2.2 Control and Instrument Systems

The information in this section of the reference ABWR DCD, including all subsections, tables, and figures, is incorporated by reference with the following departures.

Figure 2.2.1 Rod Control and Information System Control Interface Diagram

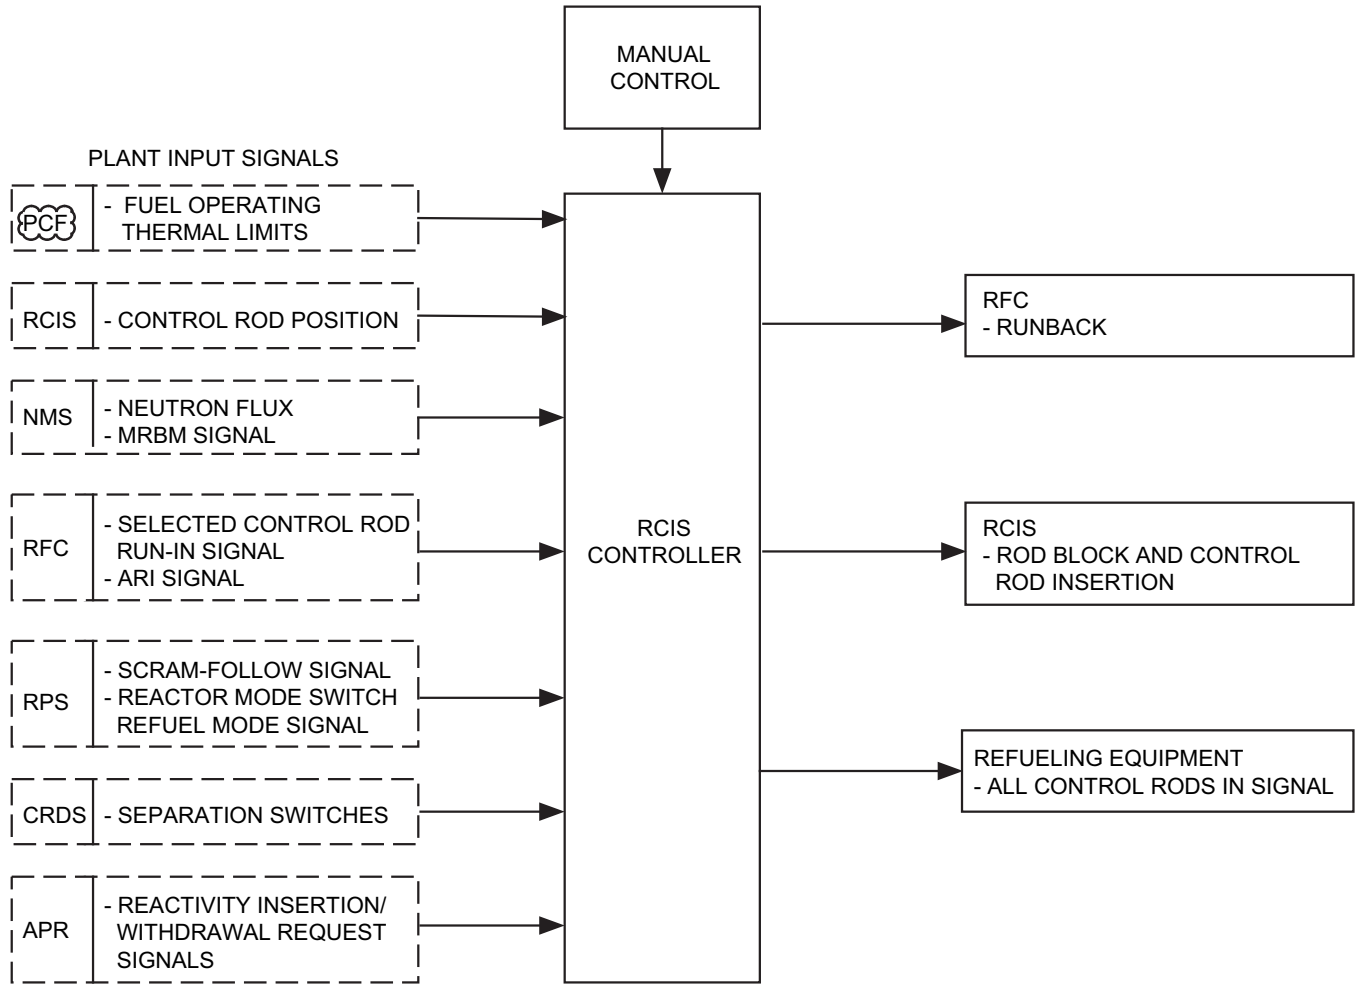
STD DEP T1 3.4-1 (Figure 2.2.1)

NOTE:
1. INTERCONNECTIONS MAY BE FIBER-OPTIC OR METALLIC.

Figure 2.2.7b Reactor Protection System

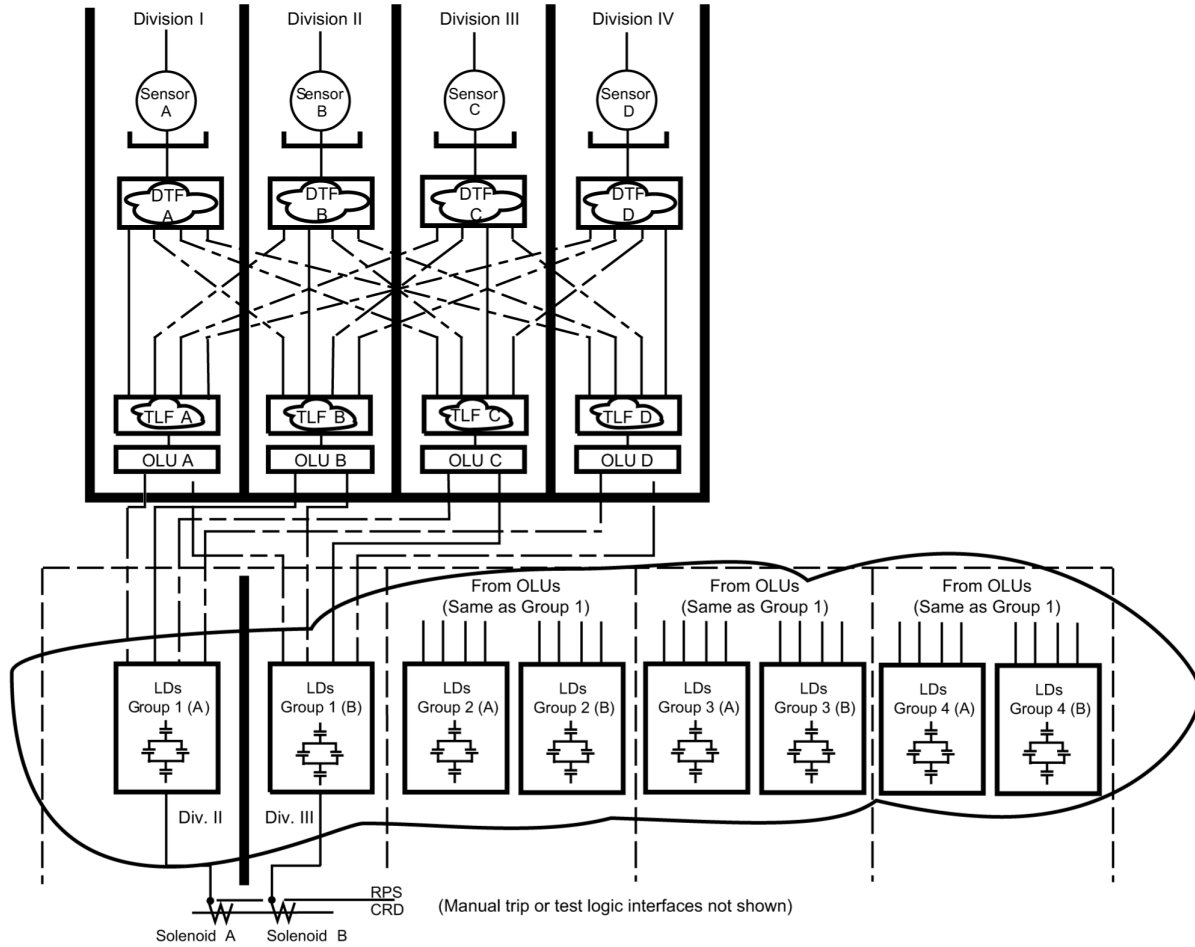
STD DEP T1 3.4-1 (Figure 2.2.7b)

The RPS has four divisions. Figure ~~2.2.6a~~ 2.2.7b shows the RPS divisional aspects and the signal flow paths from sensors to scram pilot valve solenoids. Functions Equipment within an RPS division consists of include sensors (transducers or switches), I/O, ~~multiplexers~~, data communication, digital trip modules functions (DTM DTF), trip logic unit function (TLU TLF), output logic unit (OLU), and load drivers (LD). The LDs are only in Divisions II and III. The (DTF) and (TLF) are performed in digital configurable logic devices. The data communication functions are described in Section 2.7.5.
